Meeting of the Upper Thames River Conservation Authority
Hearing Committee – Agenda
Thursday June 29, 2023 12:30pm 1424 Clarke Road, London

5. Application #61-23

Proposed interference with a wetland and to permit development within an erosion hazard associated with a river or stream valley and within an area regulated by the Upper Thames River Conservation at 290 Pittock Park Rd., Woodstock

To: Chair and Members of the UTRCA Hearings Committee
From: Jenna Alain, Manager, Environmental Planning and Regulations
Ben Dafoe, Land Use Regulations Officer
Date: June 20, 2023
Agenda #: 5
Subject: Section 28 Permit Application #61-23: Proposed Replacement Construction of Existing Detached Single Family Residence, 290 Pittock Park Road, City of Woodstock

**SITE PLAN
PREPARED FOR BUILDING PERMIT
AND LOT GRADING
FOR: EVEREST ESTATE HOMES**

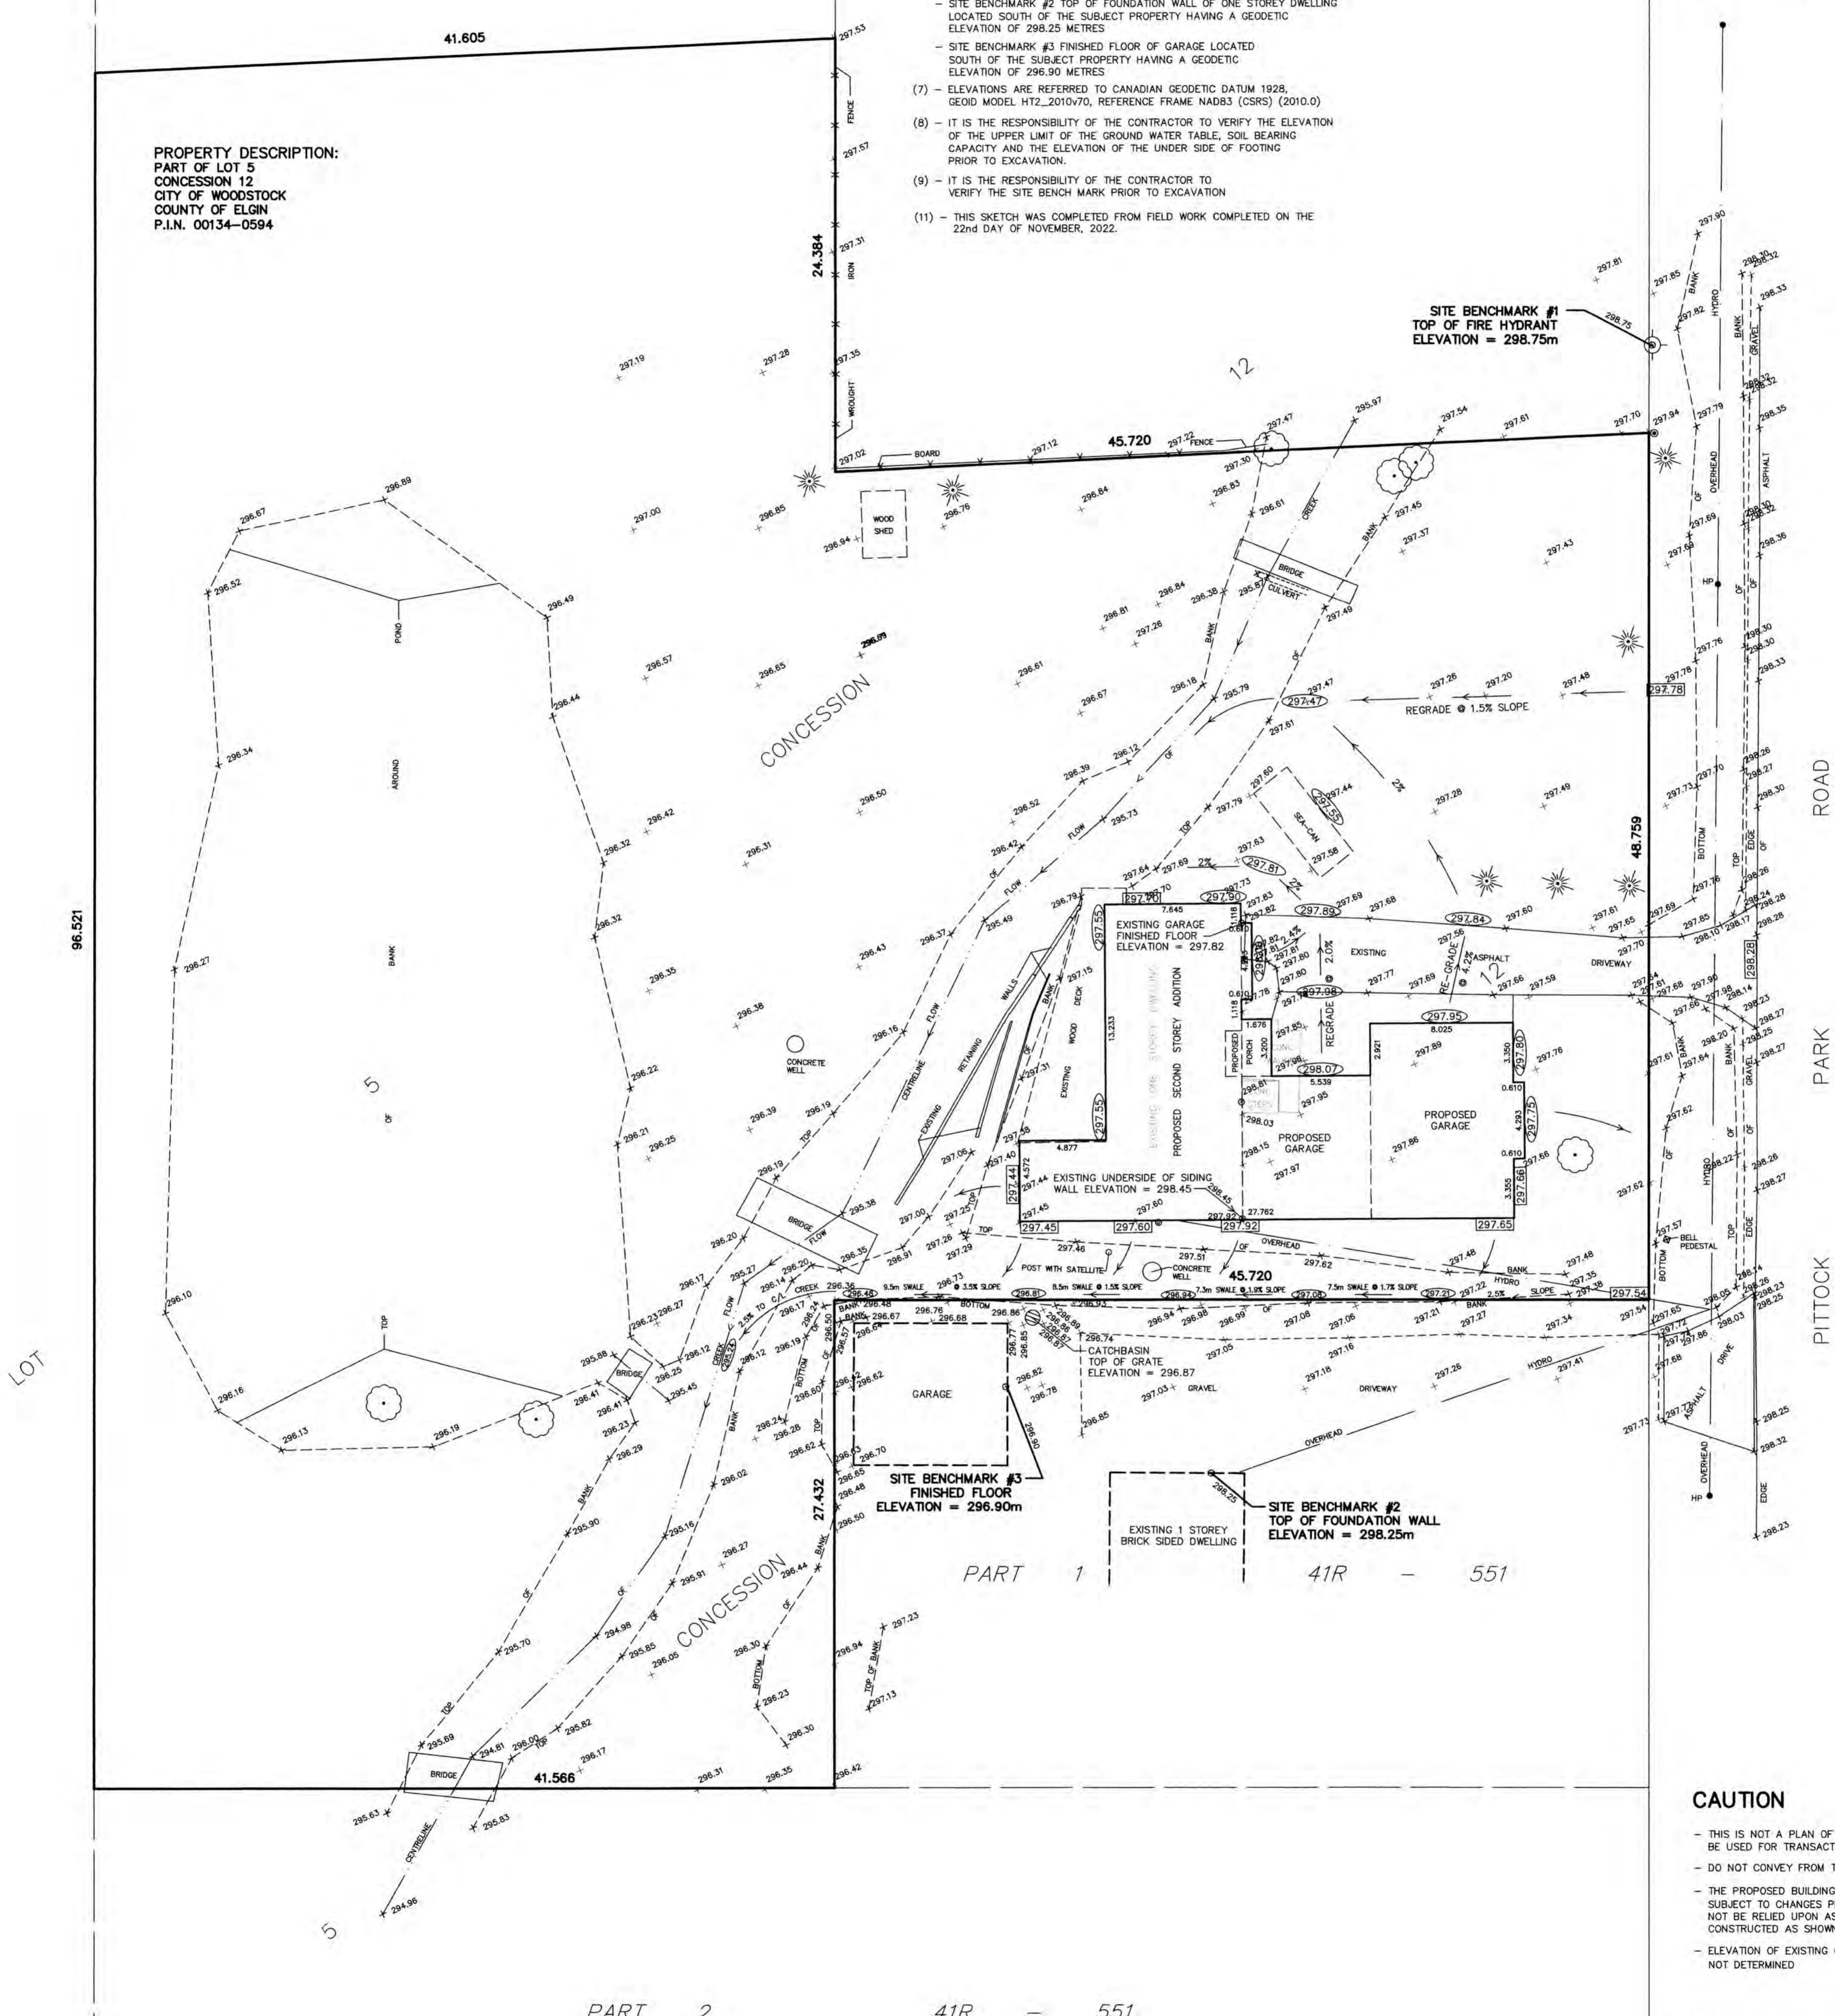
UTRCA can confirm we have received your plan of survey. As previously mentioned, would you be able to send a set of building design drawings detailing the new garages as well as upper floor for staff review. Please indicate overall measurements of new additions (both second storey and shop/garage). Please also indicate development limit/setbacks from top of bank of the adjacent Benfield Drain. It appears some grading is being proposed within the previously communicated 15m setback from the adjacent drain-further discussion required here.

- UTRCA would not support grading/filling in the yard within 15m of the Benfield drain as detailed on the grading plan provided.
- The UTRCA would not support a "phasing process" of 2 separate applications, where the second floor addition would be initially permitted, and then at a later date the garage was applied for through a s28 permit.

You'll notice the only grading within 15 M of the adjacent drain proposed is to avoid pooling. We can maintain the exact grades in that 15 M area; however we are not changing flow patterns, just ensuring a proper 2% grade is maintained. Let me know if I need to show the existing grades as the proposed grades.

FOUNDATION PLAN

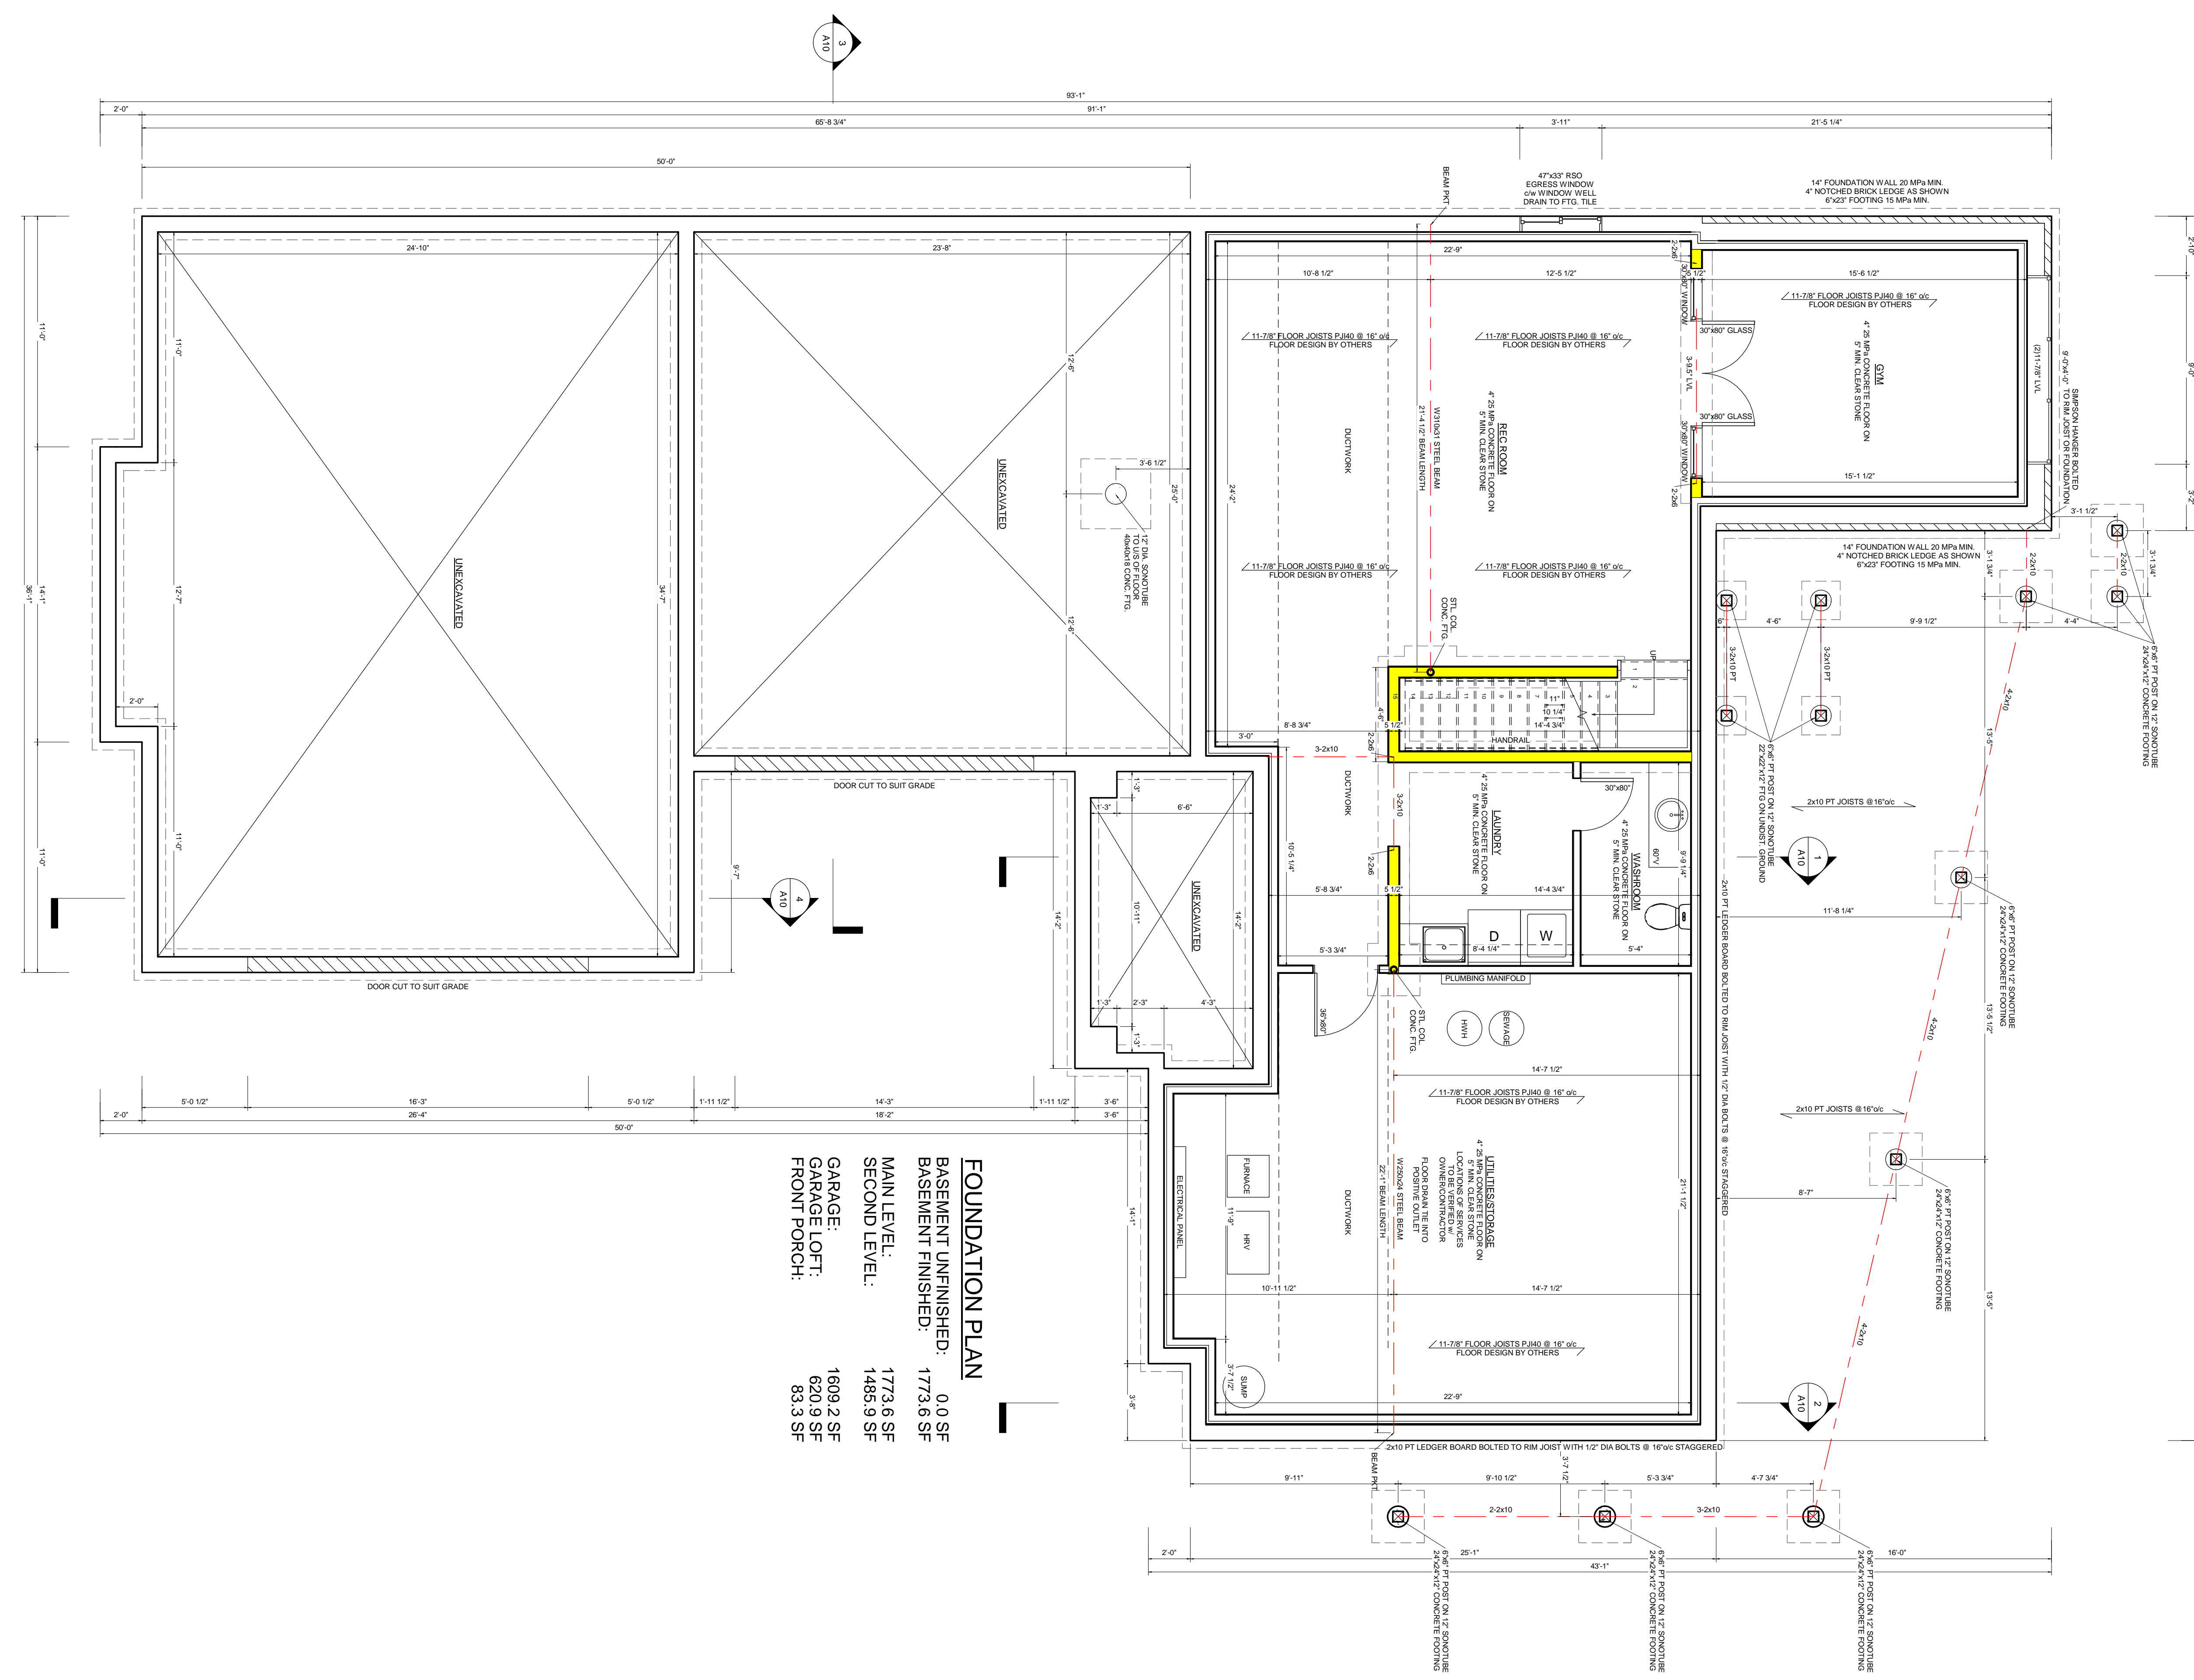
- The current proposed deck on the North portion of existing home would also not be permitted within the 15m setback as previously communicated.
- The currently proposed modifications to foundation openings within the existing home would need to be reviewed and approved. Confirmation of floodproofing of these newly proposed opening would be required. UTRCA policies would not support new openings (doors, windows, servicing vents, etc.) that would result in a structure becoming more flood-prone.

- The plan denotes this is a "rebuild". Please clarify-Acknowledging our phone conversation, there may be better opportunity and application of policy if you are in fact rebuilding/removing/replacing foundation of the existing structure. If this in fact a rebuild, including new foundation/footings there may be some opportunity to relocate the structure outside of the erosion hazard and the minimum watercourse setback. The new proposed location would require confirmation through a geotechnical study. This may allow for the proposed second floor, provided the size increases (Gross Floor Area and Footprint) are maintained within standards noted above.
